## NEW AIR SHIFT SEALS

**PTO-TEC-86**

**DATE:** September 15, 1997

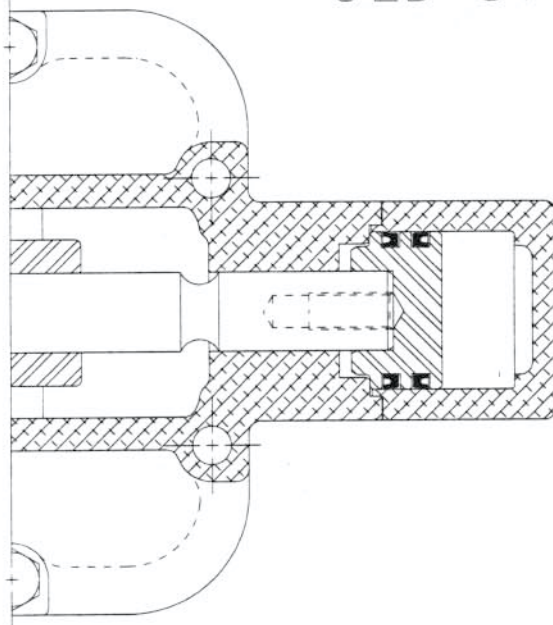
To enhance the sealing of the piston and air shift cylinder in our air shift covers, a running change will be made to our 880 and 941 Series air shift assemblies starting September, 1997. This change affects the 329101X air shift cover used for the 880 and 941 Series which contain the floating piston, part number 66-P-21, and the block vee rings, part number 28-P-257. The existing piston 66-P-21 will be replaced by a new piston—part number 66-P-23. The old style block vee rings, 28-P-257, are being replaced by part number 28-P-61 which is an O-Ring design.

For service purposes on 880 or 941 Series that uses the old style piston use service kit 328356-60X—this kit will contain the new style O-Rings and piston. Do not use the Block Vee Rings (28-P-257) with the new piston (66-P-23) or the O-Rings (28-P-61) with the old style piston (66-P-21). While the outside diameter and width of the piston do not change, the depth of the groove for the seals do, so the seals are not interchangeable between the pistons. The existing air shift cover seal kit, 328356-54X, will be updated to contain the 28-P-61 O-Rings.

Shown on the reverse side of this bulletin are drawings of the old and new style assemblies for your reference.
